<b>DOCUMENT CONTROL</b> 		<b>DATE &amp; TIME FOR ASSEMBLY</b> DIMENSIONS ARE IN INCHES FRACTIONS: 1/16, 1/8, 1/4, 3/8, 1/2, 5/8, 3/4, 7/8, 1	
<b>MATERIAL</b> CS85 STRUCTURAL INSULATION		<b>THIRD ANGLE PROJECTION</b> 	
<b>APPROVALS</b> DRAWN: S. EPP CHECKED: ALAN R. QUINN APPROVED: [Signature] DATE: 14 MAR 07		<b>DATE</b> 14 MAR 07	
<b>PROJECT</b> HALL A - TRANSVERSE - EXP E06-010 TARGET SYSTEM OVEN ASSEMBLY CS85 TRANSVERSE WALL US		<b>SCALE</b> 1:1

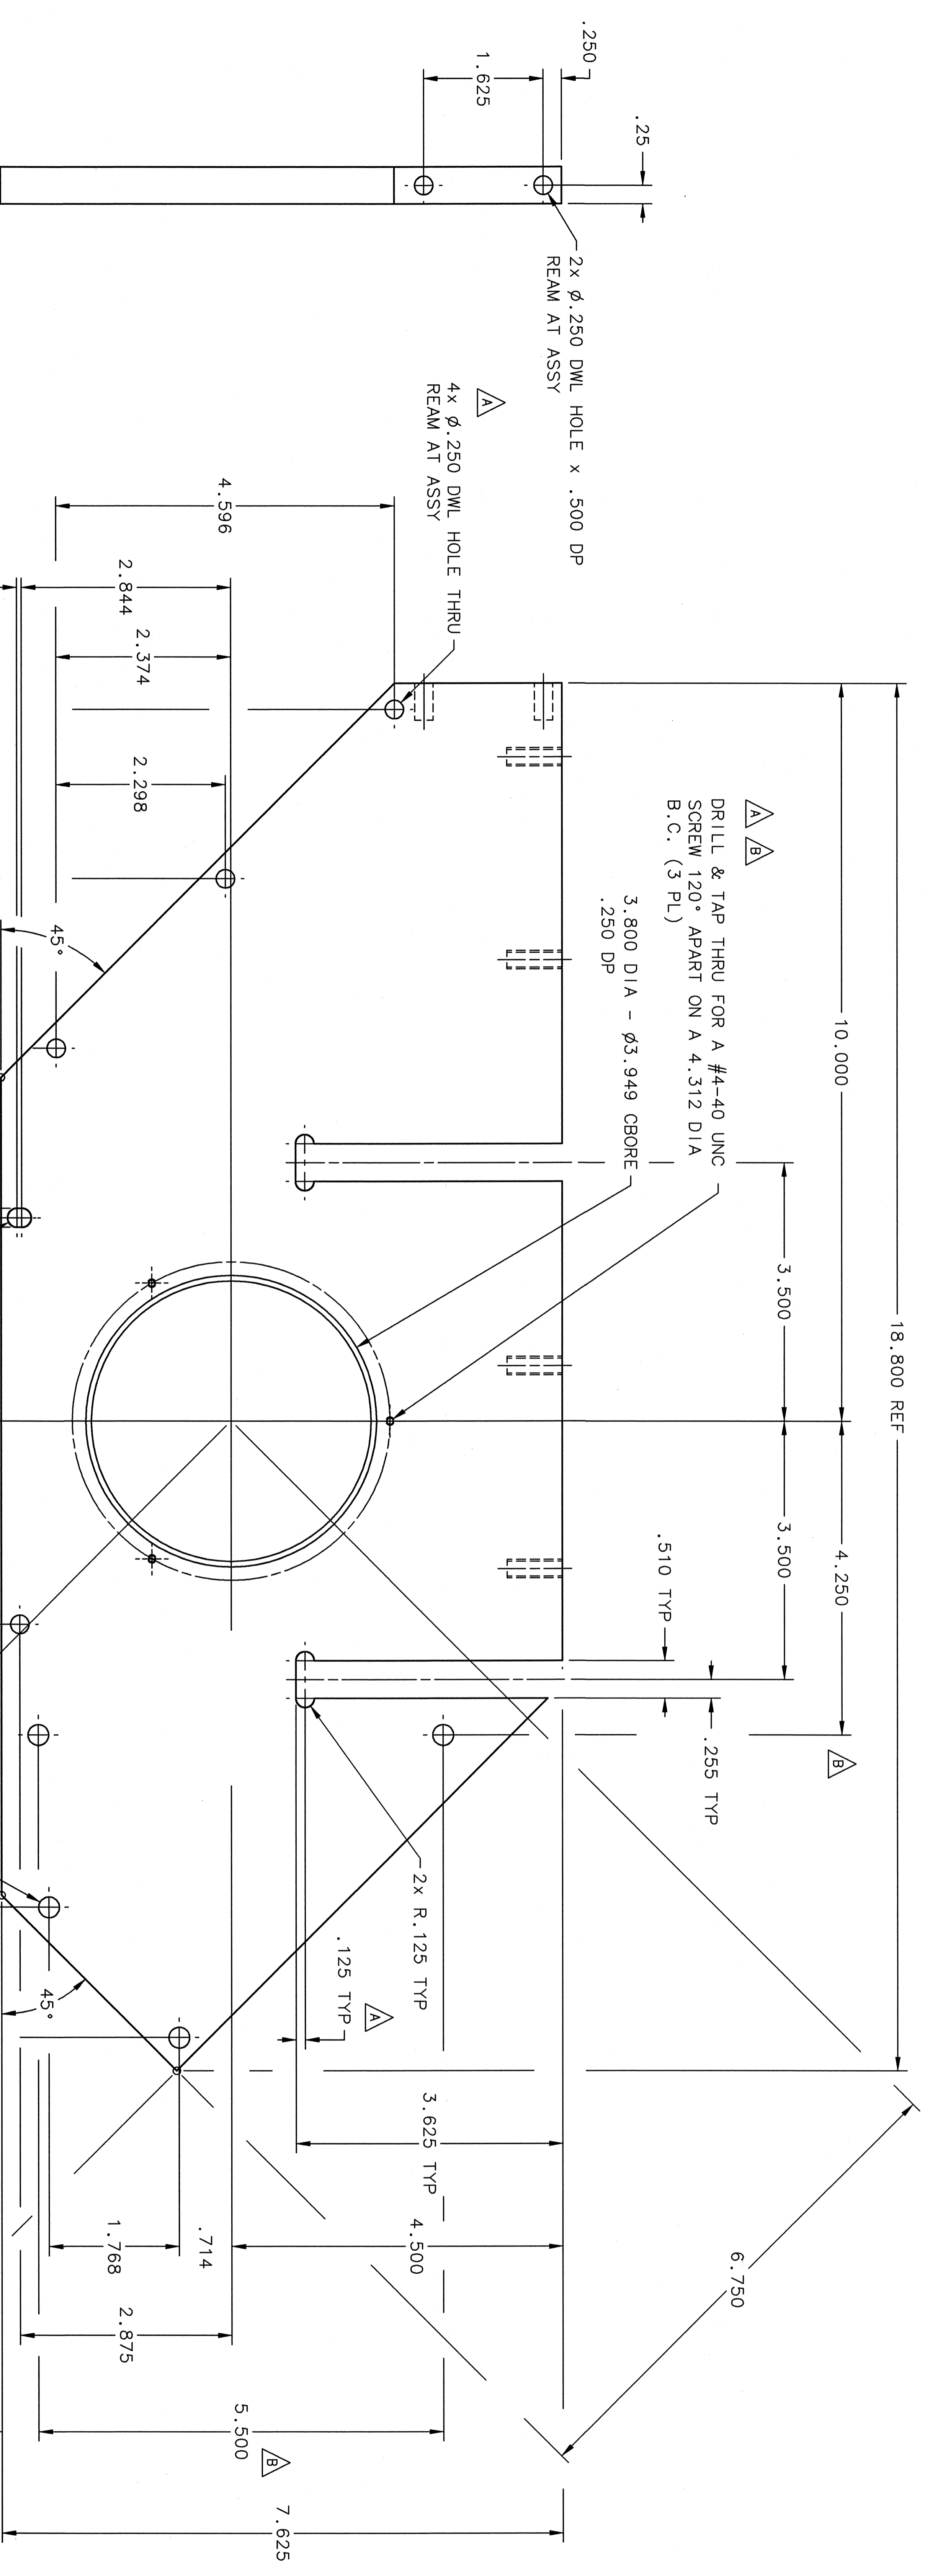
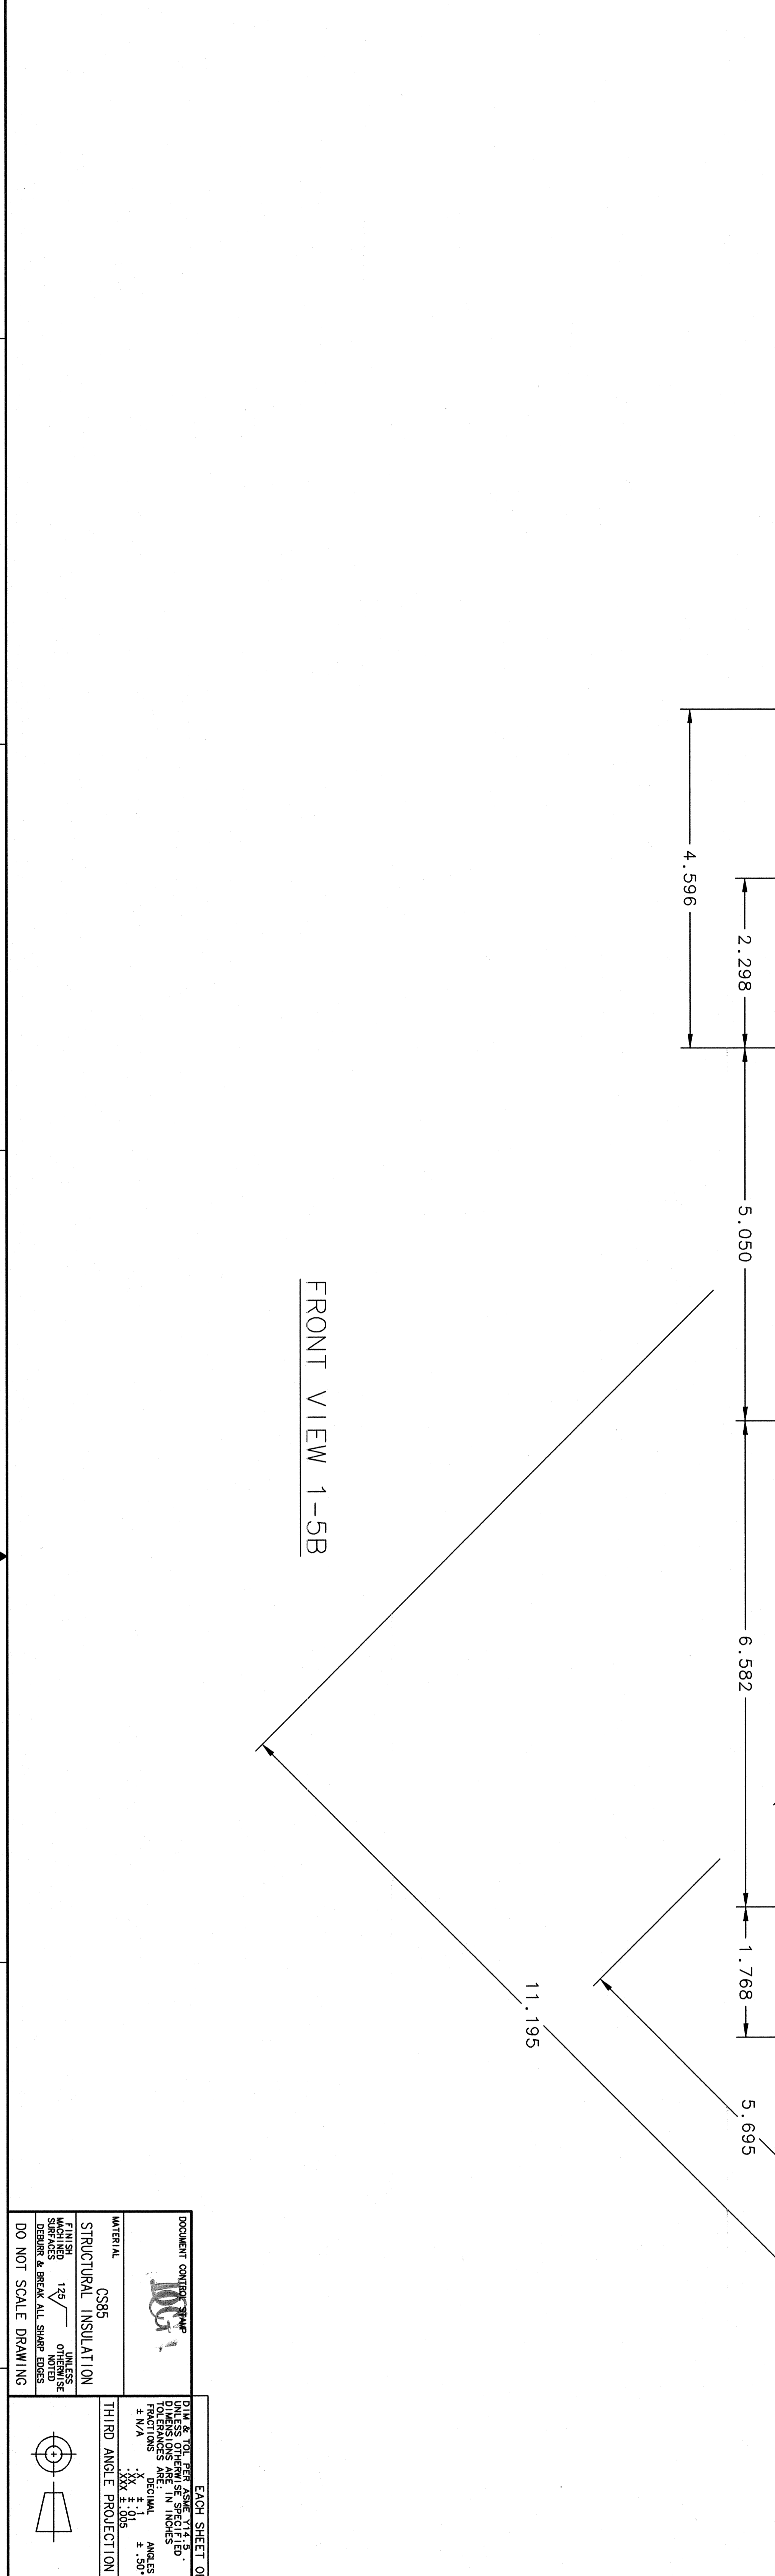
ZONE	REV	DESCRIPTION	DATE	APPROVED
1-4H	A	ADDED #10-24 UNC HELICOILS (4 PL) HOLES WERE 1/4-20 UNC.	17 AUG 07	SME
1-8F	A	ADDED #4-40 UNC HELICOILS (3 PL)		
1-7E	A	4x $\phi$ .250 DWM HOLE THRU WAS 5x.		
1-5D	A	$\phi$ .250 DWM HOLE THRU CHANGED TO A SLOT. ADDED DIM'S TO LOCATE & DESCRIBE SLOT.		
1-3E	A	REMOVED SECTION VIEW 1-2C. CHANGED .125* CHAMFER WITH A .125 R IN EACH CORNER OF OUTOUT (2 PL) ADDED DIM'S TO LOCATE POSN OF RADII'S.		
1-6F	A	ADDED NOTE 1.		
1-4H	B	PART NAME WAS CHANGED FROM Z TRANSVERSE WALL US TO CS85 TRANSVERSE WALL US. MATERIAL CHG FROM ALUMINA-SILICA Z-500 TO CS85 STRUCTURAL INSULATION. DRILL & TAP FOR A 1/4-20 UNC SCREW (4 PL) WAS FOR A #10-24 UNC SCREW (4 PL)	28 NOV 07	SME
1-6F	B	REMOVED NOTE 1. HELICOIL - NITRONIC 60 INSERT. HELICOILS ARE NO LONGER REQUIRED		
1-4F	B	ADDED TWO .281 DIA CLEARANCE HOLES AND THREE LOCATIONAL DIMENSIONS.		
1-2E	B
